Re: Abengoa Mojave Solar Project (09-AFC-5): Supplemental Written Response to Data Request Set 1B (nos. 1-86)

Soils and Water Resources (21-61)

Application for Certification for the **ABENGOA**)
MOJAVE SOLAR POWER PLANT)

Figure 41B-1. Location of key existing wells near the Abengoa Solar Energy Project site. Hydrographs of select wells are found in Figures 41B-2 through 41B-6.

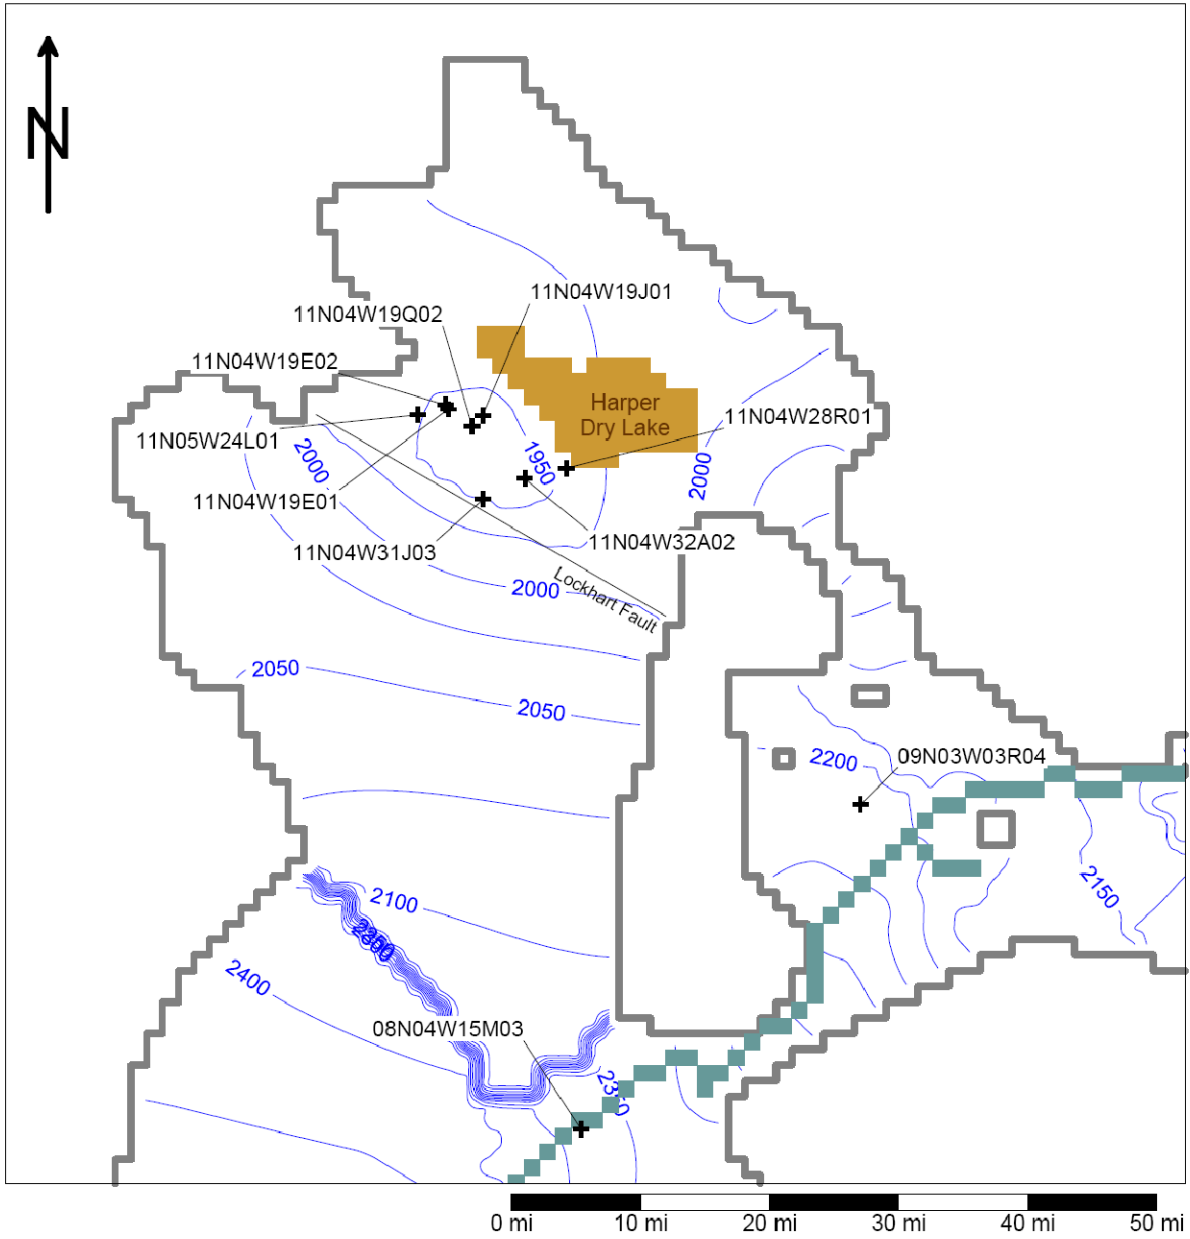
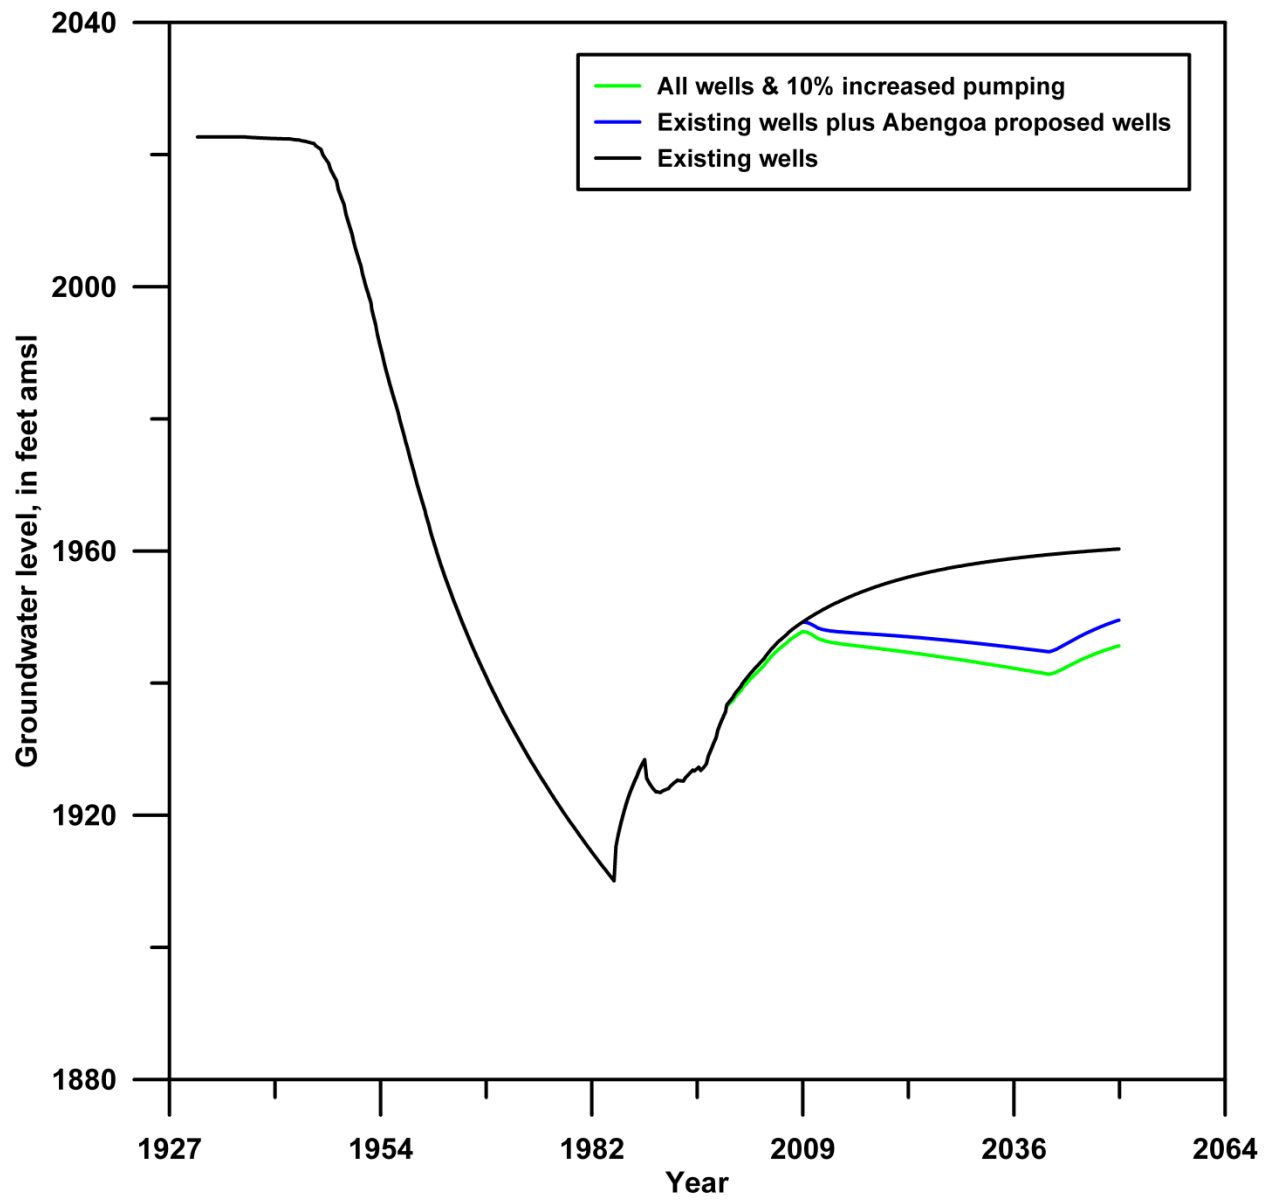
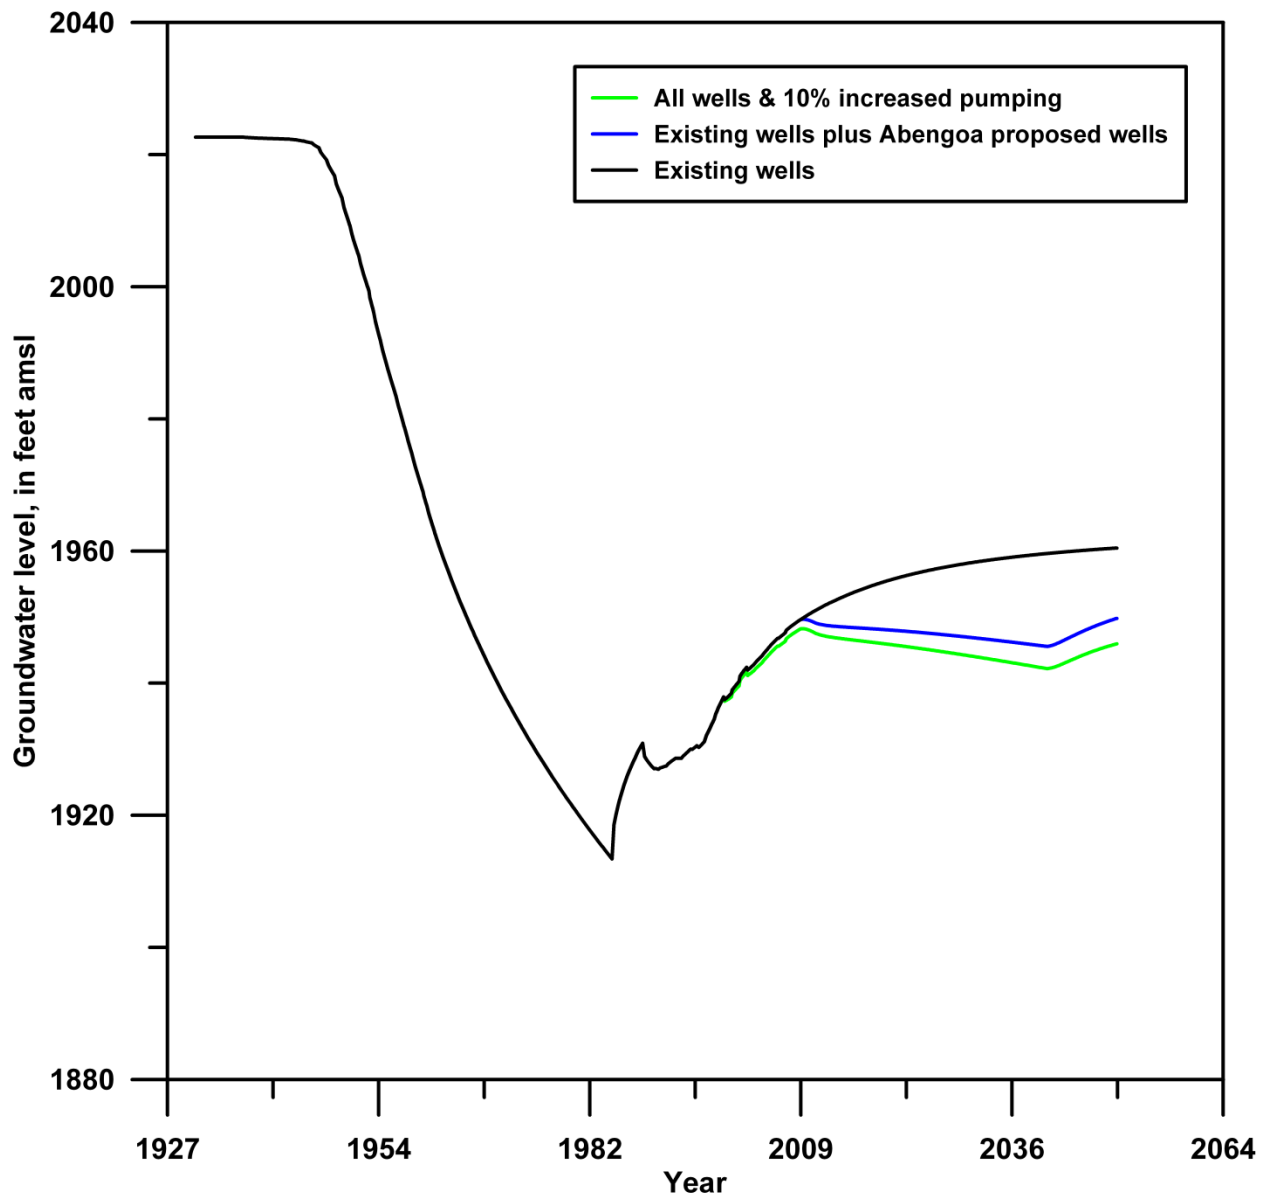
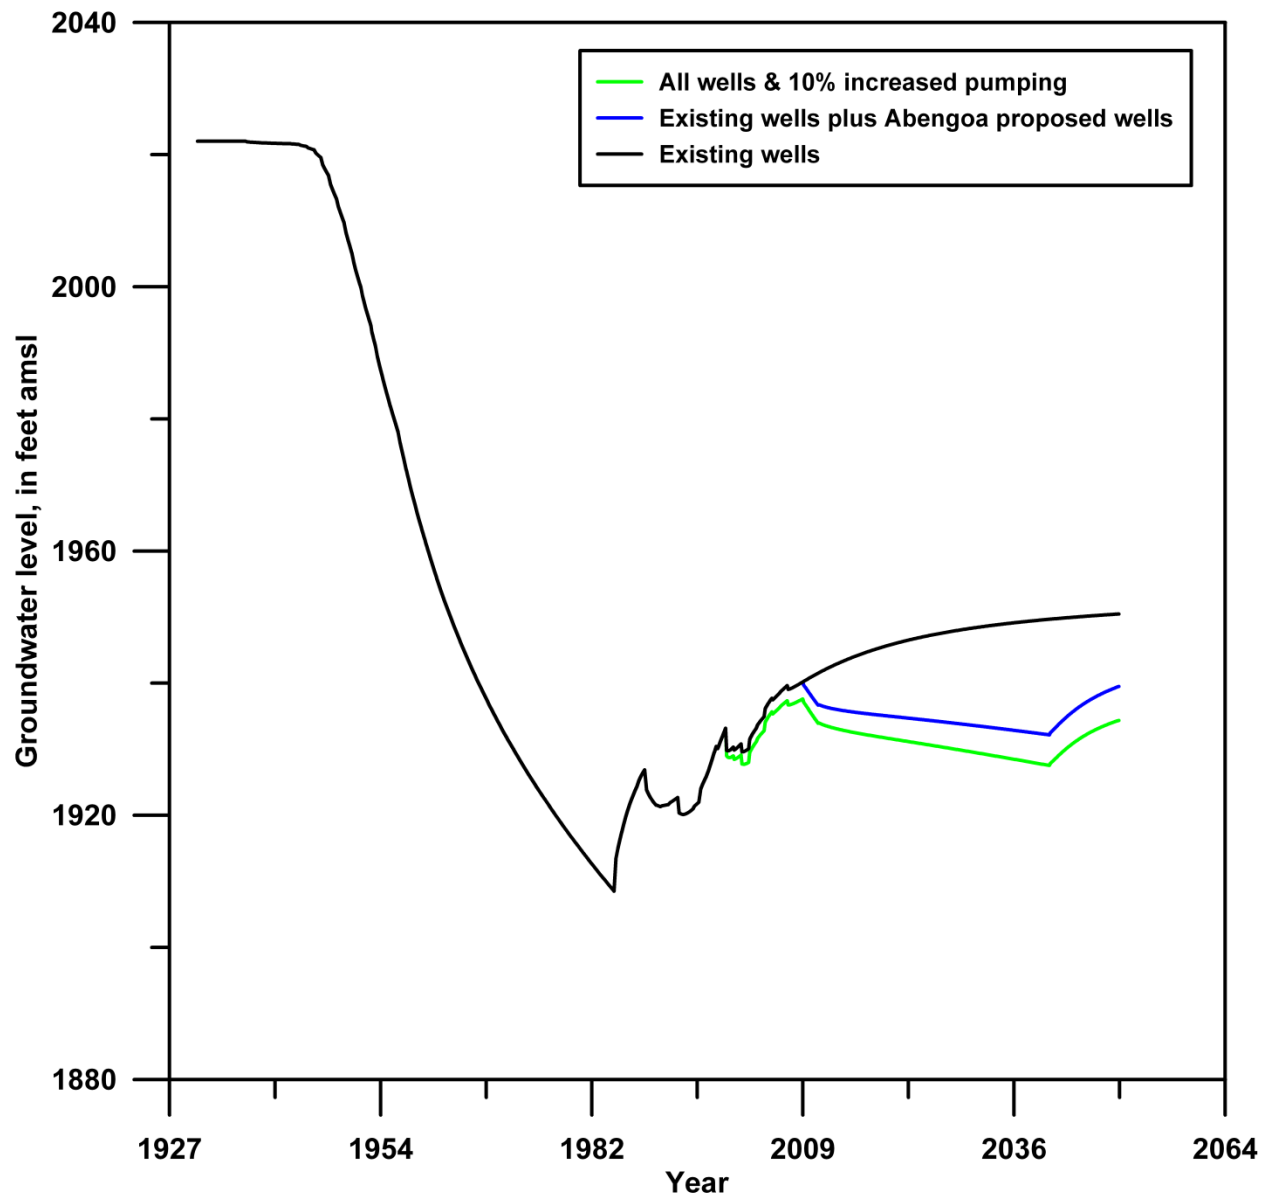
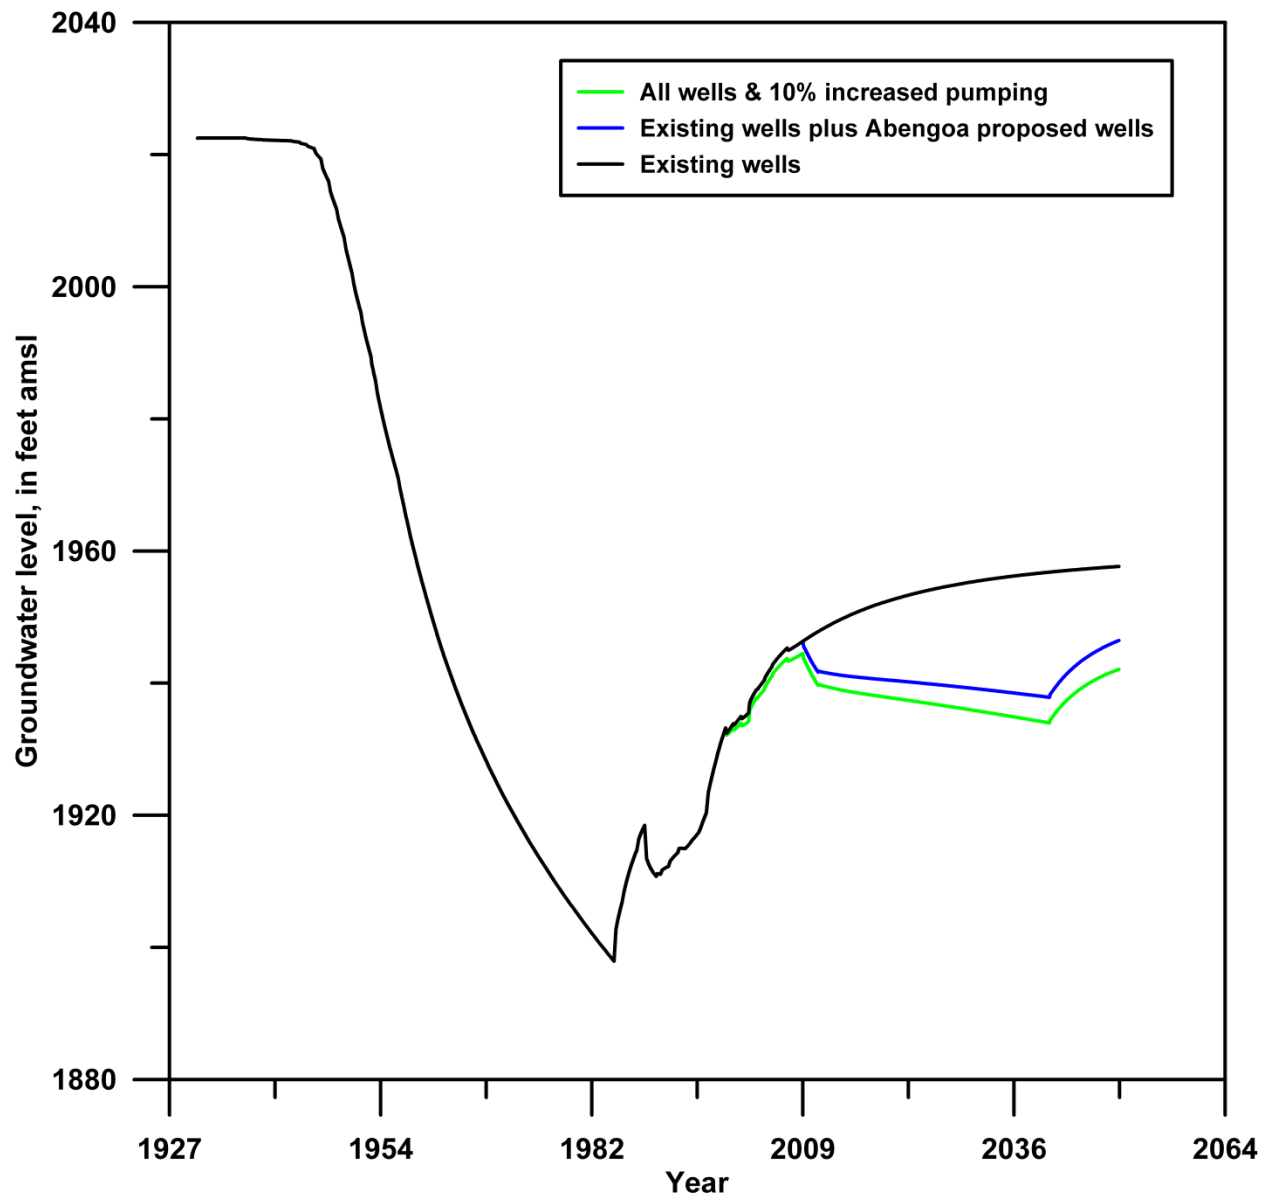
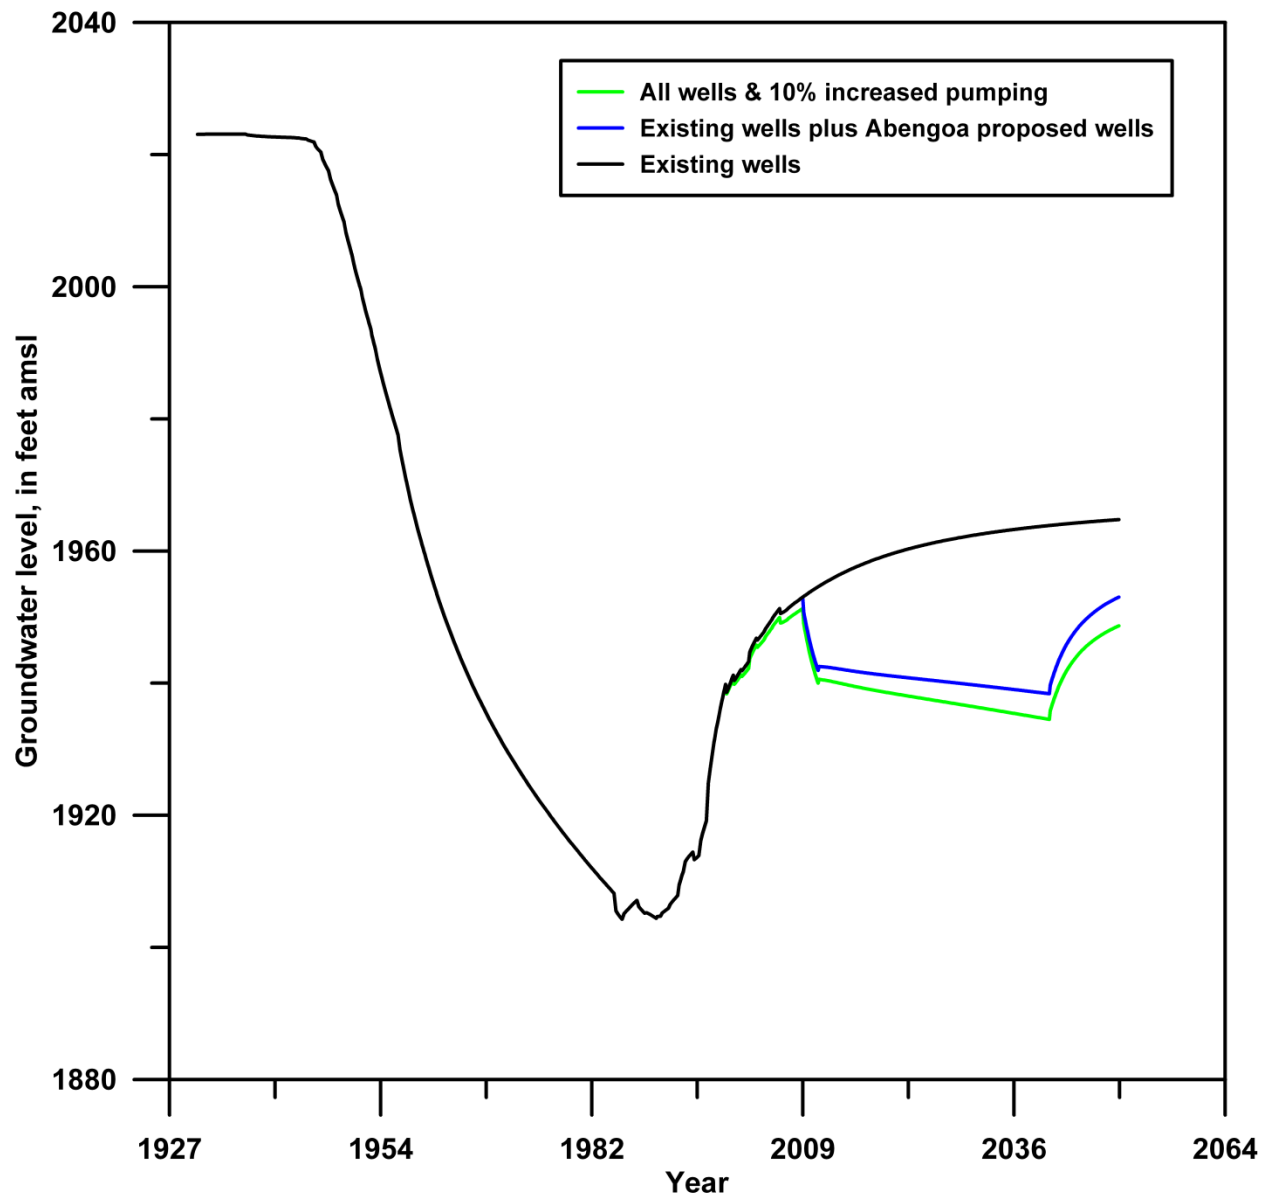
- A. Please conduct a cumulative impact simulation that includes pumping from SEGS VIII and IX supply wells and irrigation, and municipal and domestic wells in the modeled area.
- B. Provide a tabulation of the simulated construction period and 30-year project pumping drawdown at key existing wells shown in *Figure 1-2*.

- A. Our cumulative impact simulation includes all the wells in the HVGB region as provided in the response to Data Request 42. Figures 31-1 and 31-2 show the drawdowns in the HVGB and Figures 41A-1 and 41A-2 show drawdowns in the vicinity of the Abengoa Mojave Solar Project site.
- B. Table 41B-1 provides a tabulation of drawdown at key wells near the project site. Locations of these wells are shown in Figure 41B-1. Hydrographs for these same key existing wells are found in Figures 41B-2 through 41B-6.
